FCAN CARD IMMUNITY ON ACS380

TA21-312-C

Product Improvement Program (PIP) :		Service bulletin :		Instructions :	
Crane family : GMA		Range : HUP		Model : HUP40/30 and 32/27	
C	Technical Support	July 30th, 2021	Code change 84115199, page 6		
B	Technical Support	July 1st, 2021	Modification		
A	Technical Support	June 24th, 2021	Creation		
Index	Written by	Date	Comment

Solution 1:

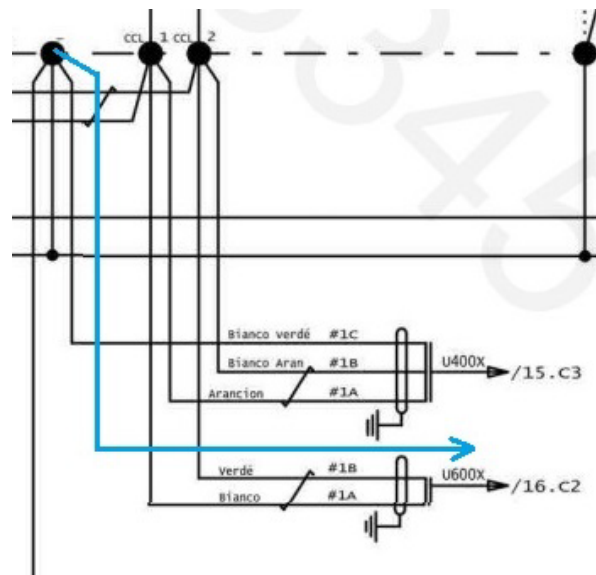
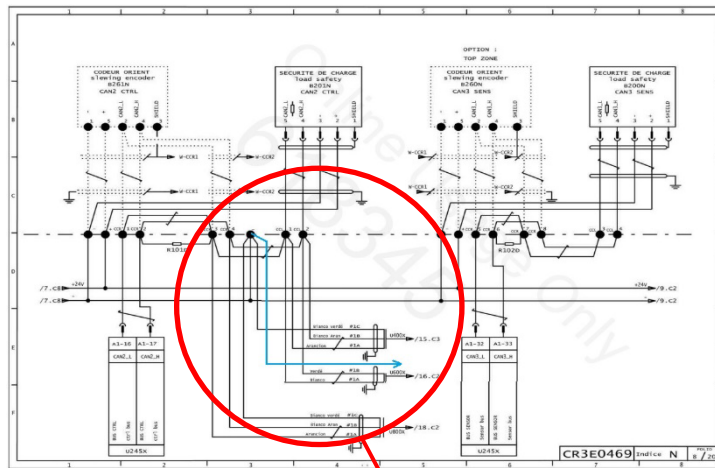
DIAGNOSIS	<p>The slewing ACS380 drive stops during a deceleration phase of the slewing motion, the drive indicates a 5091 status (CAUTION, this status is not always due to a CAN card fault). EMC disturbances corrupt the exchange between the CAN card and its drive. In this case the ACS380 drive stops. This fault can be identified by losses in the steering converter device only.</p>
SOLUTION	<p>To this date, we have identified that the more sensitive FCAN-01-M ACS380 cards have a serial number starting with 026:</p> <div style="text-align: center;">  </div>

To restore robustness, terminal 3 of the FCAN connector must be referenced to the 0V of the crane.

Solution 2:

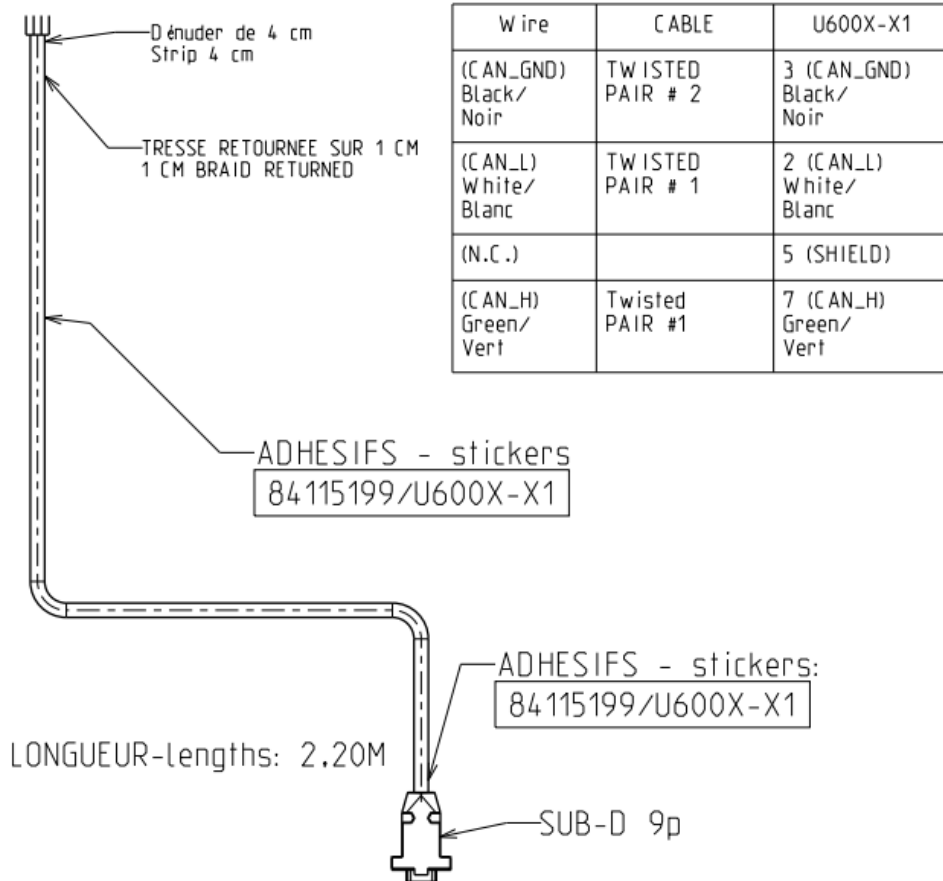
The 84115199 cable available in PR can be used temporarily:

Connect the wires:

- White => CAN_H => CCL2
- Brown => CAN_L => CCL1
- Yellow => GND => 0V
